Proposal for the 06 series of amendments to UN Regulation No. 46 (Devices for indirect vision)

The text was produced by the Taskforce on UN-R46 and is superseding document ECE/TRANS/WP.29/GRSG/2023/23

- (i) Edge of the reflecting surface enclosed in a protective housing
- (ii) Reflecting surface projects beyond the protective housing in a specific adjustment position
- (iii) Edge of the reflecting surface not enclosed by the protective housing

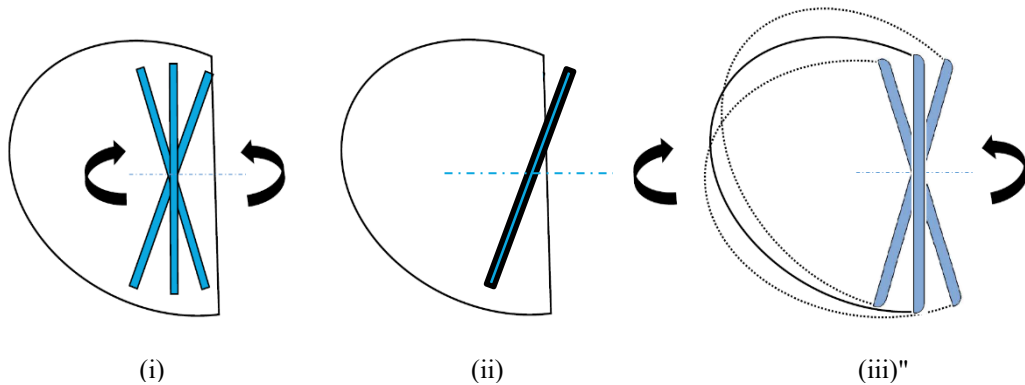
When the edge of the reflecting surface is enclosed in a protective housing, the radius of curvature "c" on the housing's perimeter shall be not less than 2.5 mm at all points and in all directions, figure below (i).

When If the reflecting surface projects beyond the protective housing in any adjustment position (figure below (ii)), the radius of curvature "c" on the edge of the projecting part shall be not less than 2.5 mm and the reflecting surface shall return into the protective housing under a force of 50 N applied to the point of greatest projection, relative to the protective housing, in a horizontal direction, approximately parallel to the longitudinal median plane of the vehicle.

When the edge of the reflecting surface is not enclosed by the protective housing independent from any adjustment position, the radius of curvature "c" on its perimeter shall be not less than 2.5 mm at all points and in all directions and shall apply to the edge of the projecting part, figure below (iii).

Figure 9.1

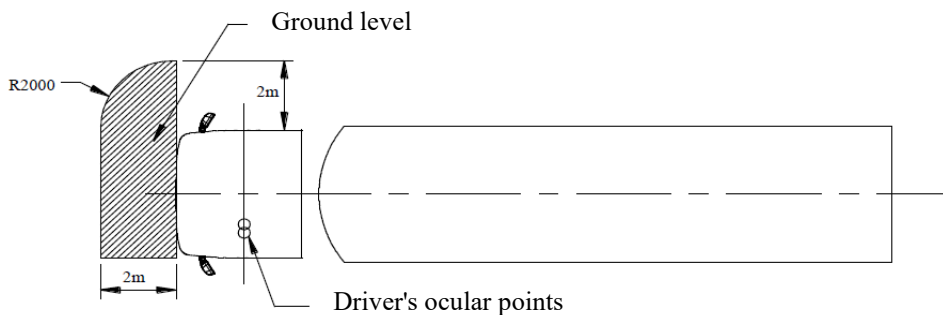
"15.2.4.6.1. The field of vision shall be such that the driver can see at least a flat horizontal portion of the road, which is **for side-steered vehicles** bounded by:

- (a) A transverse vertical plane through the outermost point of the front of the vehicle;
- (b) a transverse vertical plane 2,000 mm in front of the plane defined in (a);
- (c) a longitudinal vertical plane parallel to the longitudinal vertical median plane going through the outermost side of the vehicle at the driver's side; ~~and~~
- (d) a longitudinal vertical plane parallel to the longitudinal vertical median plane 2,000 mm outside the outermost side of the vehicle opposite to the driver's side.; **and**

- (e) ~~The~~ the front of this field of vision opposite to the driver's side may be rounded off with a radius of 2,000 mm (see Figure 9.1).

Figure 9, renumber as Figure 9.1. and amend to read:

**"Figure 9.2
Class VI field of vision for centre-steered vehicle"**

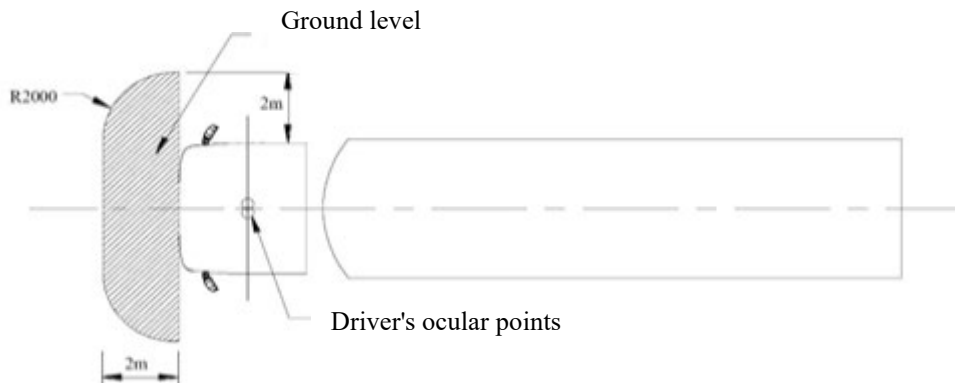
The field of vision shall be such that the driver can see at least a flat horizontal portion of the road, which is for centre-steered vehicles bounded by:

- (f) A transverse vertical plane through the outermost point of the front of the vehicle;
- (g) a transverse vertical plane 2,000 mm in front of the plane defined in (a);
- (h) a longitudinal vertical plane parallel to the longitudinal vertical median plane 2,000 mm outside the outermost side of both sides of the vehicle; and
- (i) the front of this field of vision on both sides may be rounded off with a radius of 2,000 mm (see Figure 9.2).

Insert a new figure 9.2., to read:

Figure 1

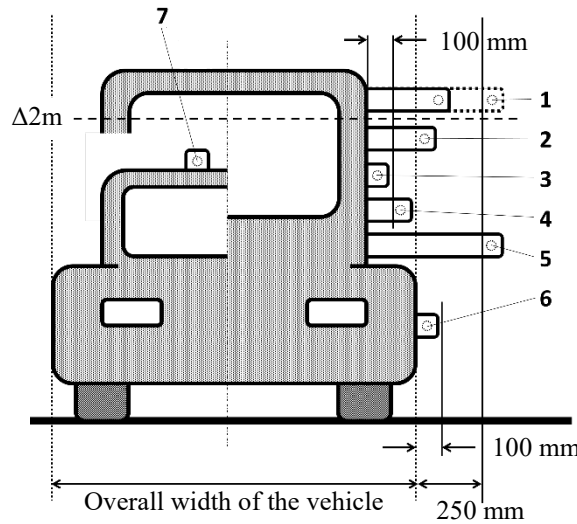
PENDULUM IMPACT TEST	
<u>Device for indirect vision CLASS II-VII</u>	
1	NO TEST (15.2.2.6.)
2	COMPULSORY
3	NO TEST (6.3.2.b))
4	NO TEST (6.3.2.a))
5	not permitted (15.2.2.6.)
6	NO TEST (6.3.2.b))
<u>Camera of CLASS I (CMS)</u>	
7	NO TEST (6.3.2.b)

4. There could be different interpretations for the term “bodywork” in paragraph 6.3.2. as it is not defined. This could lead to different designs, for which it is unclear, if the pendulum test is needed. For clarification the text was amended and a new annex with a figure for further explanation was added. This also includes Class I Camera Monitoring system (CMS) on the vehicle’s roof. The test is seen as unnecessary because a contact is seen as very unlikely.

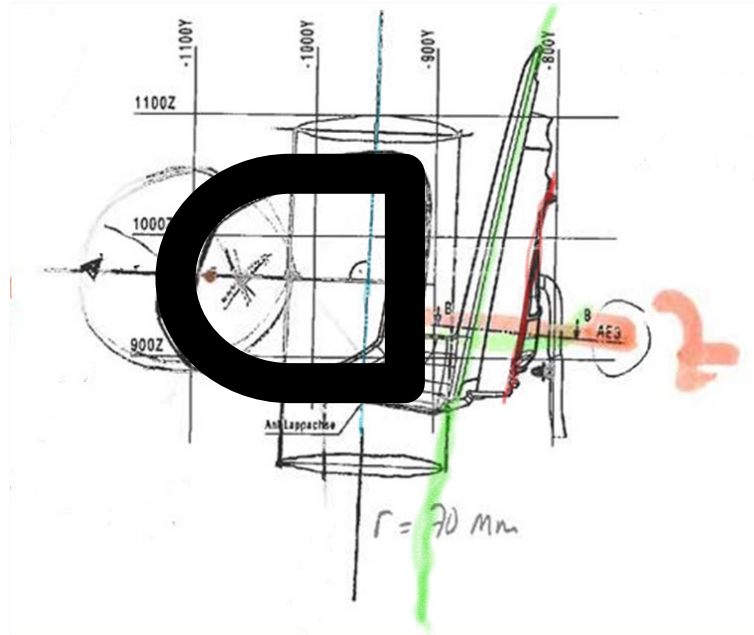
1. Proposal by OICA to introduce frameless outside mirrors, document ECE/TRANS/WP.29/GRSG/2023/16 as amended by GRSG-125-03-Rev.1. Additionally, the test procedure shall be clarified by amending paragraph 6.3.2.2.2.2. The Technical Service shall identify in consultation with the manufacturer the test positions for both directions.
2. The text of paragraph 6.1.1.6. is ambiguous. Mirrors have evolved since the original text was drafted and nowadays the surface to which the device is attached to is often not following the outer contour (green line in the figure below) of the vehicle. The attachment point is in a recess (red line in the figure below), which could lead to very different positions of the cylinder. Interpretation of the group was that the "external original surface" (green line) should be the basis for evaluation and the text was modified

accordingly and a definition for “external original surface” was included.
